**Replacement of 20 wastewater treatment systems – Phase 2
La Mauricie National Park**

Bid 5P300-16-5296

Addendum n° 1

**SNC-LAVALIN INC.
Project n°630573**

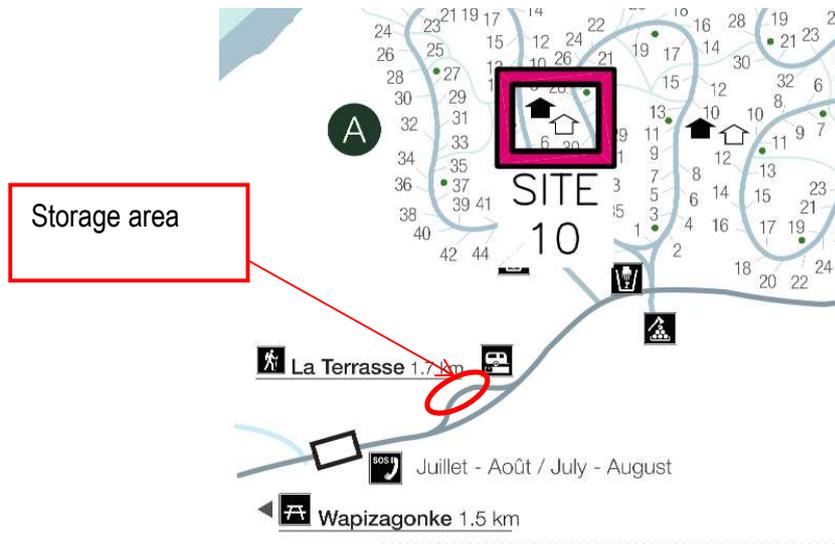
9) *Are there any planned storage area for the topsoil ?*

Yes, the road in front of the dump station, located at the entrance of the campsite, will be used as storage area. See plan below.
